ADDENDUM NO. 1

MARTIN LUTHER KING JR. COMMUNITY CENTER ROOF REPAIR / ITB 17-010

Below Number 1-4 are questions submitted in writing from a potential bidder with **responses in bold** as well as amended drawing sheets S-1, S-2 & P-1.

S-2

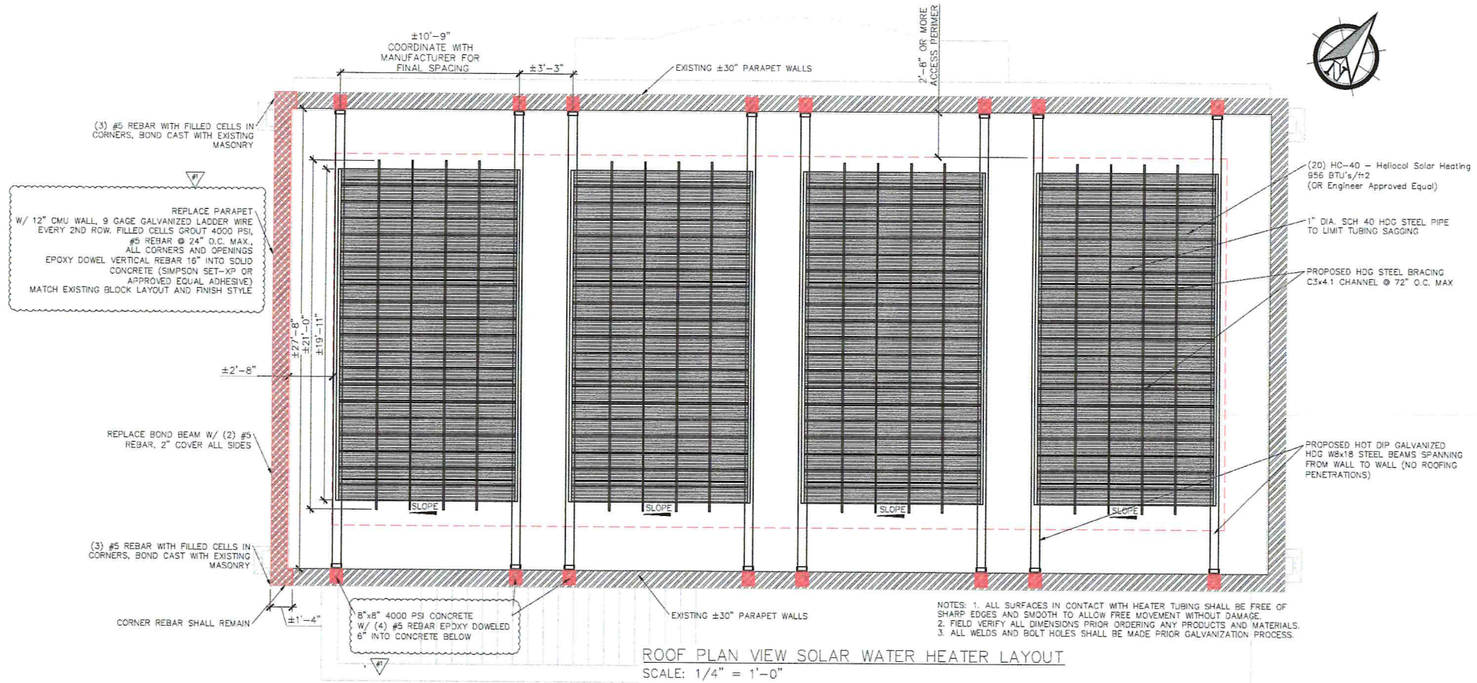
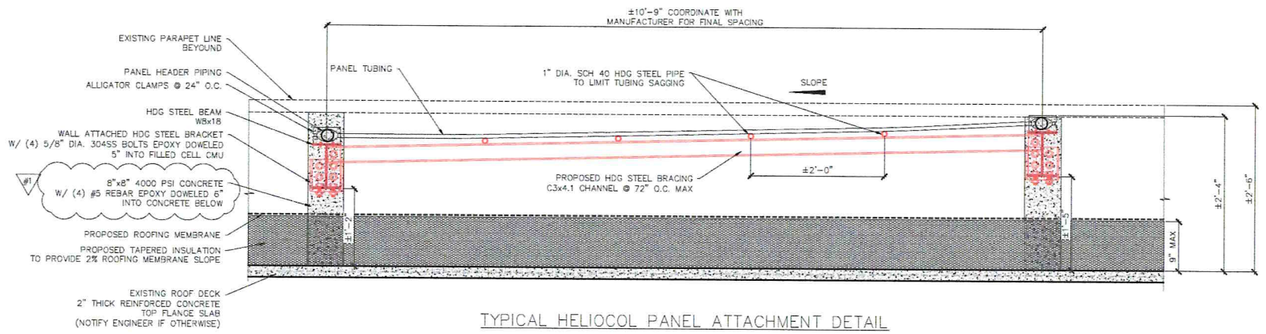
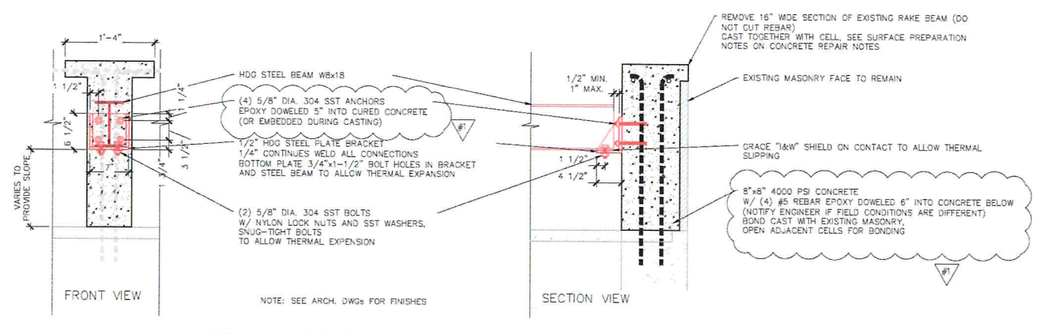
b) The drawings do not have any "***engineered details"*** on how to repairs Concrete spalling in the parapet masonry and rake beams. Please provide if this part of this RFP.

4) At the pre-bid meeting, it was observed that the existing parapet wall that will be demolished was 12" wide and new replacement wall is 8" wide according to drawings S-2. Please verify if this new all will still be built 8" wide? This will affect the roofer and the coping ect.

Response: The parapet shall be replaced as shown and described on sheet S-2 of the construction drawings.

Response: The new parapet wall is to be the same width as the existing 12" wall. The contractor shall field verify CMU block sizes upon the demolition of parapet coping and roofing membrane and match existing if different from 12" wide block.
